# Executive Director's Recommendation

<b>PROJECT</b> <b>Capital One Arena Improvements</b> 601 F Street, NW Washington, DC	<b>NCPC FILE NUMBER</b> 8617
<b>SUBMITTED BY</b> District of Columbia Office of the Deputy Mayor for Planning and Economic Development	<b>NCPC MAP FILE NUMBER</b> 21.10(38.00)46076
<b>REVIEW AUTHORITY</b> District Projects in the Central Area per 40 U.S.C. § 8722(b)(1) and (e)	<b>APPLICANT'S REQUEST</b> Approval of final site and building plans
	<b>PROPOSED ACTION</b> Approve final site and building plans with comments
	<b>ACTION ITEM TYPE</b> Staff Presentation

# Capital One Arena Improvements

Approval of Final Site and Building Plans

# Proposed Metro Entrance Changes

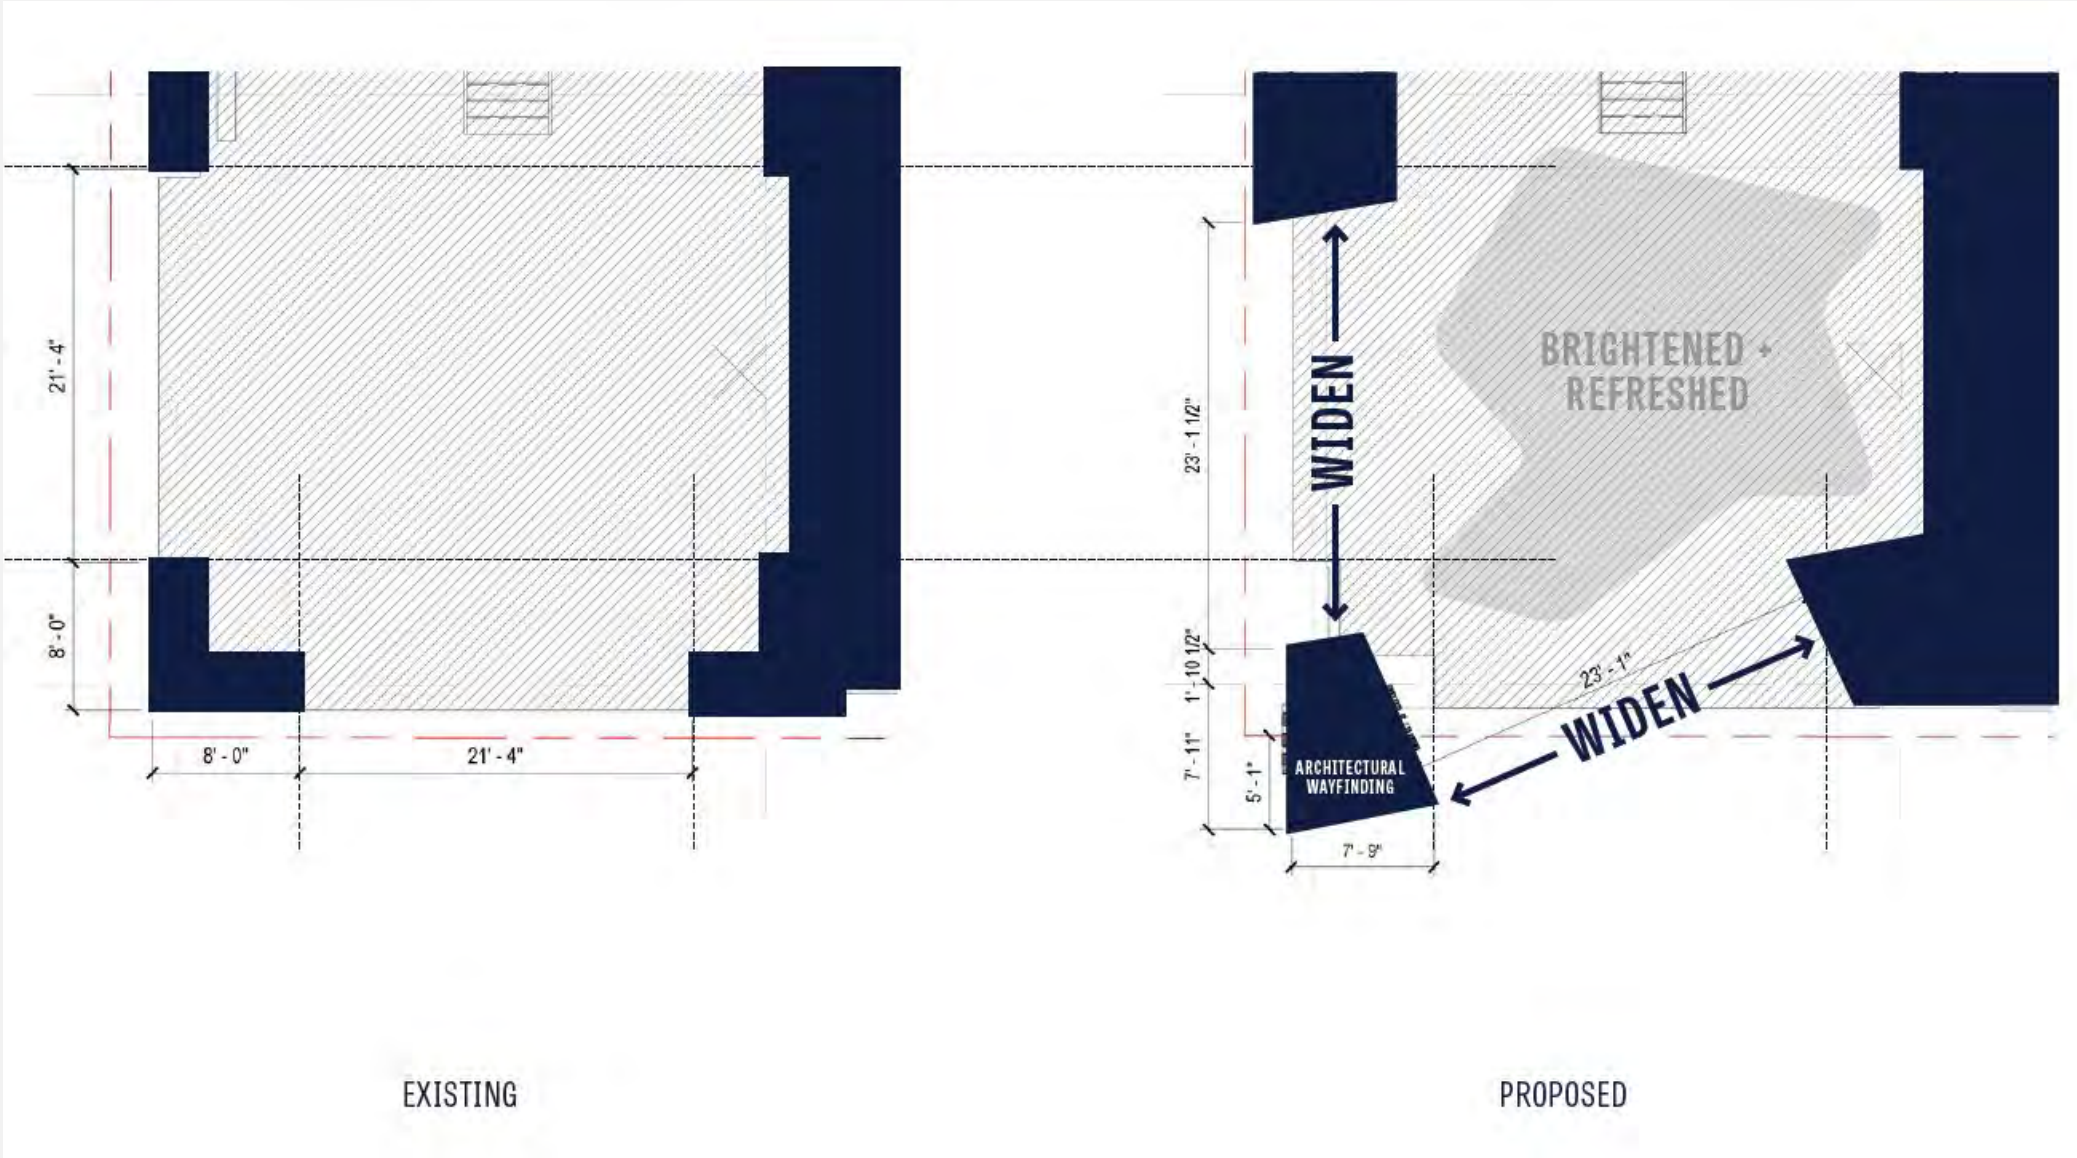
**Encourages** the applicant to continue coordination with the Washington Metropolitan Area Transit Authority regarding the modifications to the Metrorail Station entrance/exit.

The applicant has maintained minor improvements to the existing Metro entrance at the corner of 7<sup>th</sup> and F Streets. The two openings have been widening and the façade at the corner has been pushed out into the sidewalk as architectural wayfinding. The plans also note that the covered area of the Metro entrance will be brightened and refreshed. Staff supports appropriate modifications to improve access and wayfinding, but recommends the **Commission request the applicant continue coordination with the Washington Metropolitan Area Transit Authority regarding the modifications to the Metrorail Station entrance/exit.**

## METAL PANEL B

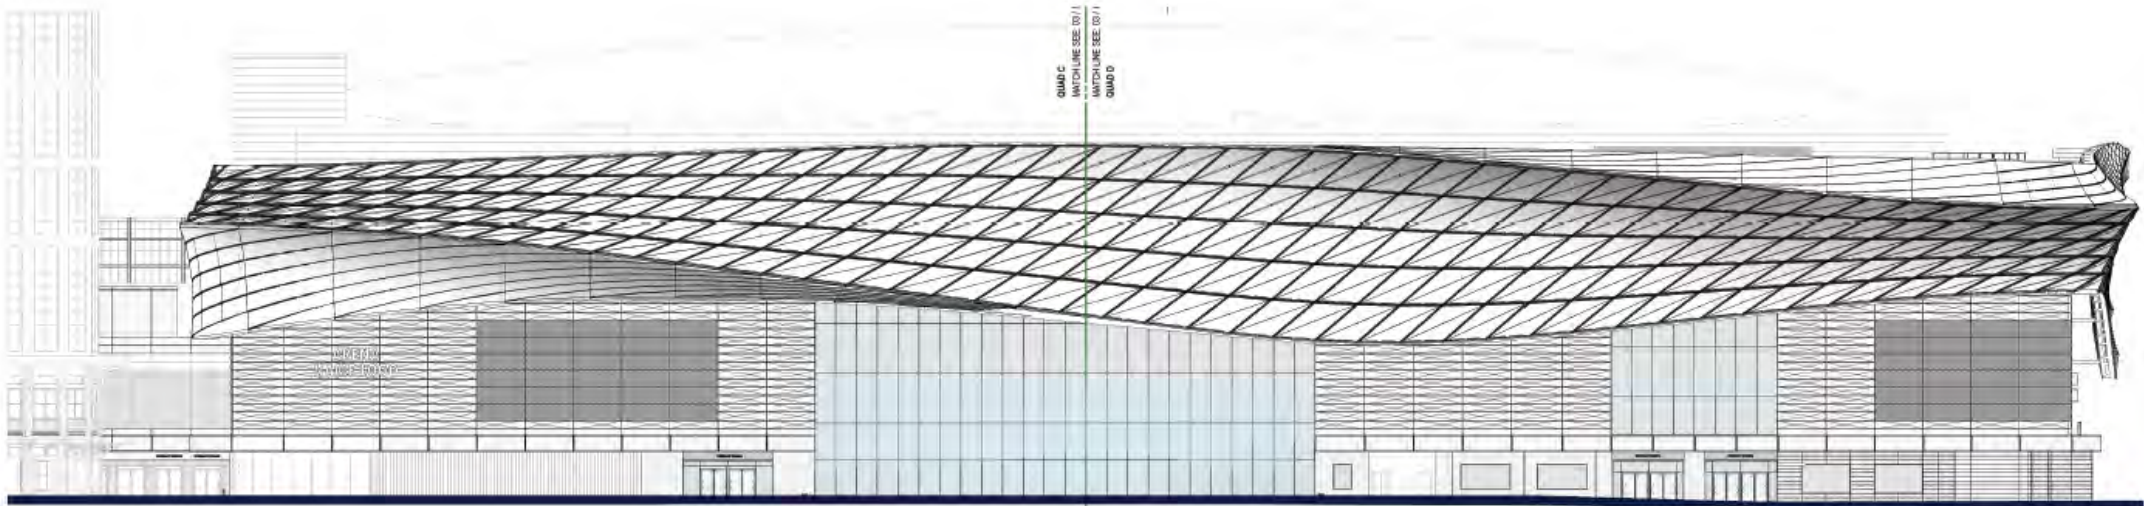
One minor change the applicant made since preliminary review is changing the Composite Wood material introduced on Gallery Place Way to a wood-colored Metal Panel. This change does not change the overall design or character and is minimally visible given its use on Gallery Place Way.

6<sup>th</sup> Street looking south

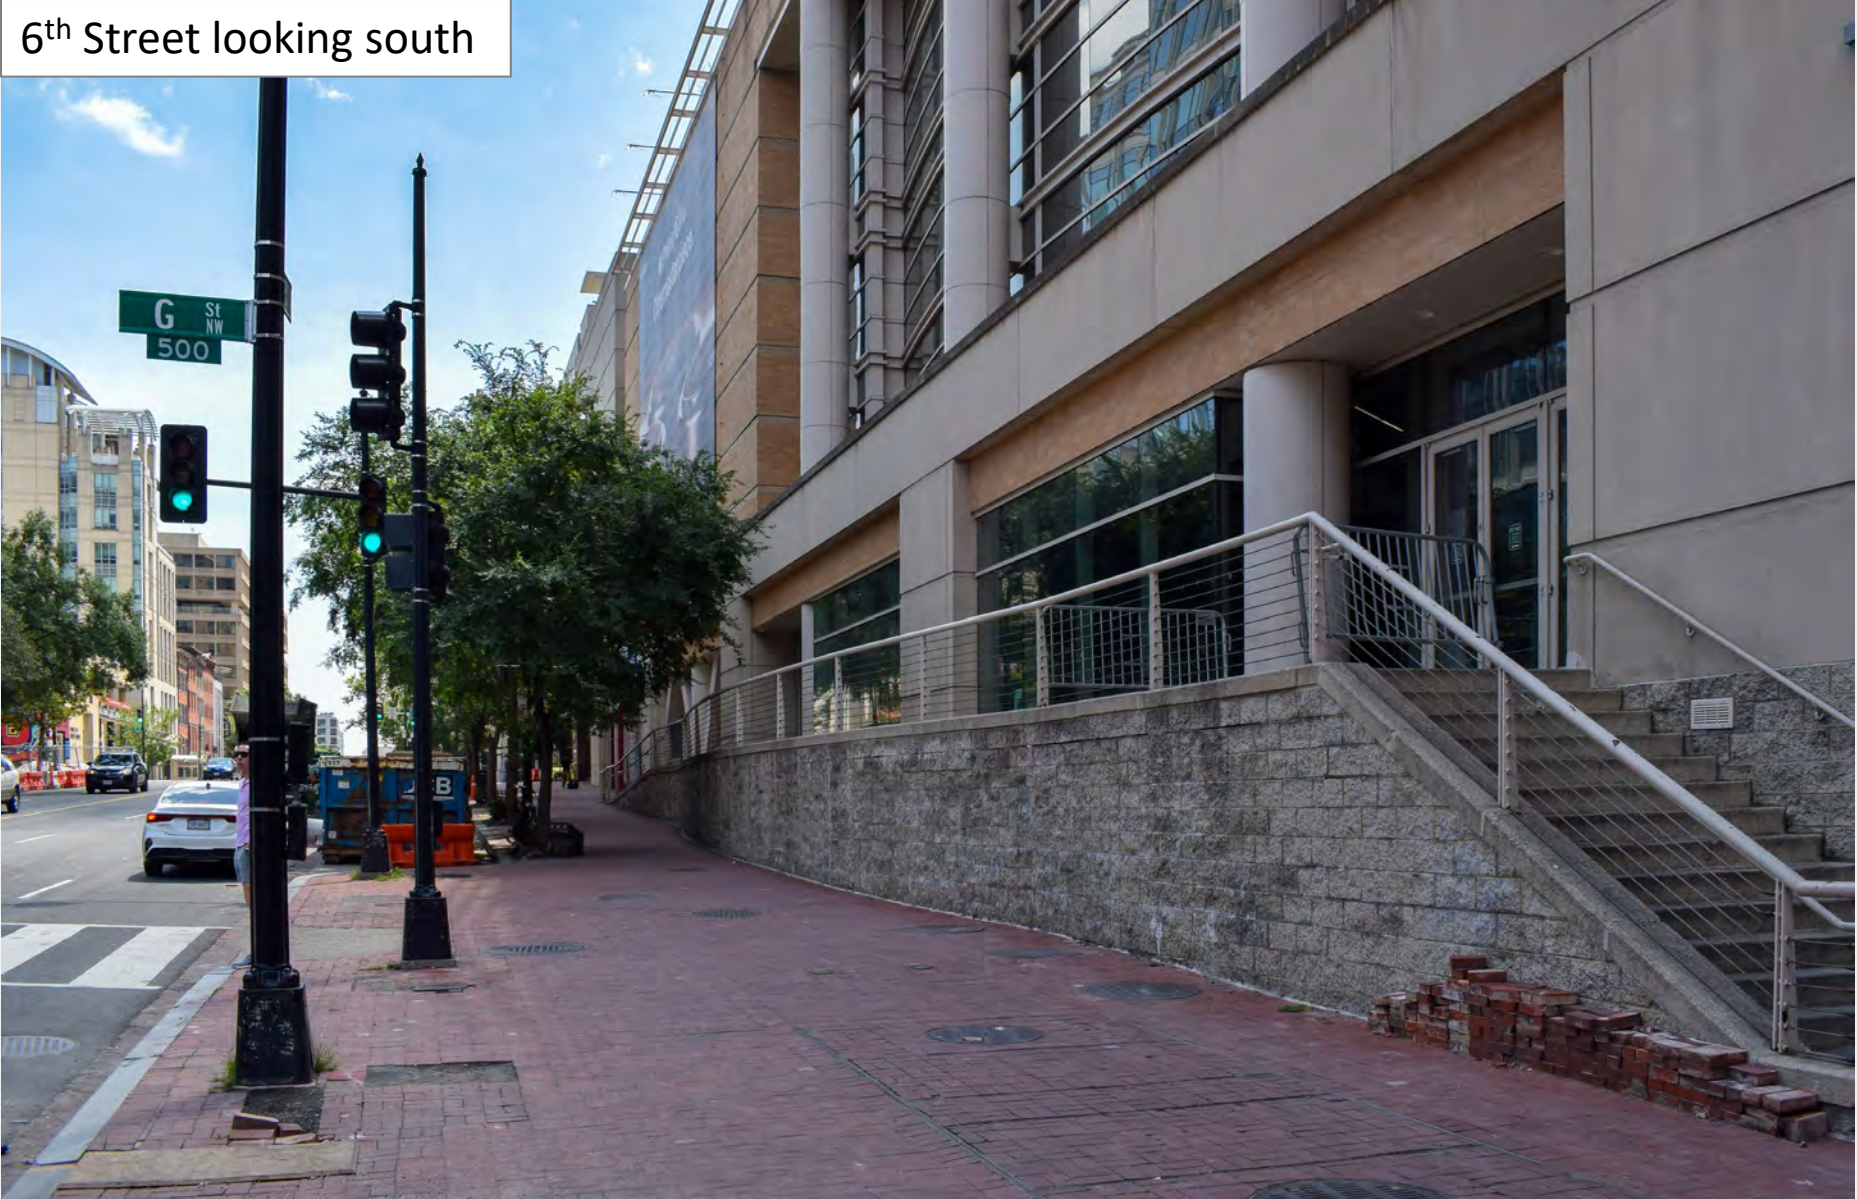
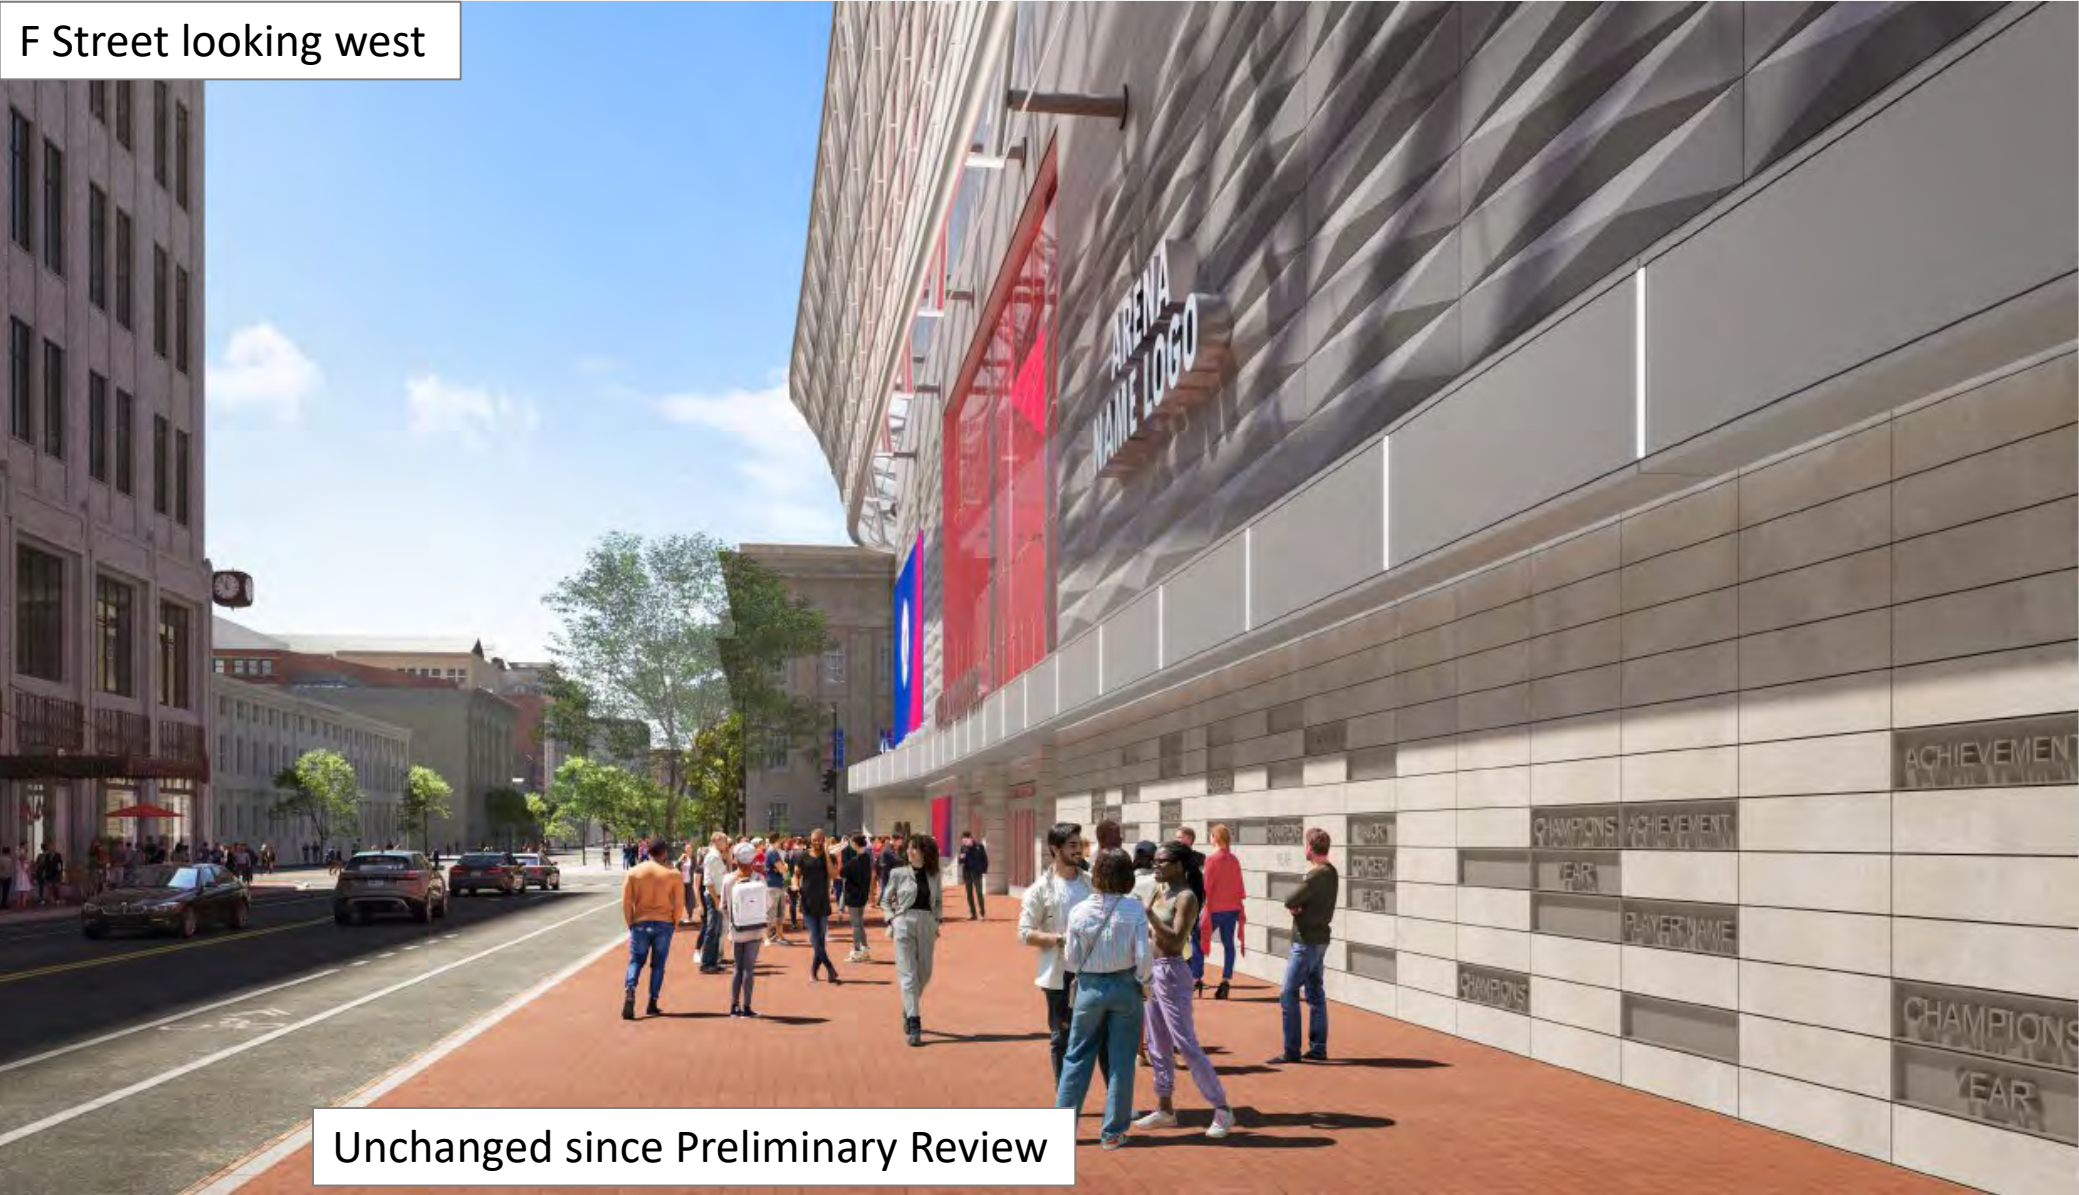
- Updated the metal elements on 6<sup>th</sup> Street to better mimic the internal framing of the veil as it continues on the façade and fades away at the north corner of the building.
- Submitted additional lighting information so that the Commission can fully understand the overall lighting intention.
- Updated the materials on Gallery Place Way which is similar to the previous material and minimally visible from 7<sup>th</sup> Street.
- Completed Section 106 consultation and the Memorandum of Agreement.

**Notes** that due to structural limitations, the applicant determined extending the veil along 6<sup>th</sup> Street was not feasible. As such, the applicant proposes to extend the idea of the veil through the use of horizontal and diagonal metal bars that relate to the structural skeleton of the veil.

**Supports** the addition of vertical and diagonal metal bars to conceptually extend the veil's structural skeleton on the 6<sup>th</sup> Street façade, noting that it successfully carries the movement and energy of the veil along the remaining length of the building façade.

The main building improvements requested by the Commission at the preliminary review relate to the conceptual extension of the veil on 6<sup>th</sup> Street. The applicant previously evaluated whether the veil could extend along the entire length of the façade, but determined this is not possible because of significant structural requirements and limitations due the Metrorail tunnel which passes below this portion of the building. In particular, the applicant is limited by the structural foundation of the existing arena, and the challenges of strengthening the subgrade foundation in order to

Instead, the applicant proposes a façade element to transition the veil along the façade that mimics the movement and dynamism of the veil. The purpose is to better unify this side of the arena with the F and 7th Street facades. At the preliminary approval, the Commission supported the concept, but recommended the applicant continue to evaluate the new design element to better achieve the goal of visually extending the veil. Since the Commission's preliminary review, the applicant has refined the conceptual extension of veil along 6th Street with the introduction of horizontal and diagonal metal bars that relate to the structural skeleton of the veil. This design refinement conceptually carries the movement and energy of the veil along the remaining length of the 6<sup>th</sup> Street façade. In addition, the applicant stated in the submission that as pedestrians move along the new 6th Street corridor, the proposed refinements will be both noticeable and impactful, enhancing the experience for event attendees and everyday users alike.

The transformation of 6<sup>th</sup> Street from current conditions, starts with a new three-story curtain wall featuring ultra-clear glazing that reveals the interior of the arena and street level retail. The existing aging precast façade will be replaced with limestone brick, introducing a refined pedestrian experience and connecting passersby to a material rooted in the city's cultural identity. Additional enhancements include a new digital board, more ultra-clear glazing at an interior stair, and a dynamic overhead lighting element with the conceptual extension of the veil, that draws pedestrians toward the updated accessible entry. This new fully glazed entry featuring ultra-clear curtain walls, limestone wall panels, and an immersive digital mesh screen that marks a significant upgrade from the current exposed ramp and block walls. These changes have worked to emphasize the veil as an element wrapping and integrating with the building, rather than hanging passively from the envelope. As such, staff recommends the **Commission supports the addition of vertical and diagonal metal bars to conceptually extend the veil's structural skeleton on the 6<sup>th</sup> Street façade, noting that it successfully carries the movement and energy of the veil along the remaining length of the building façade.**
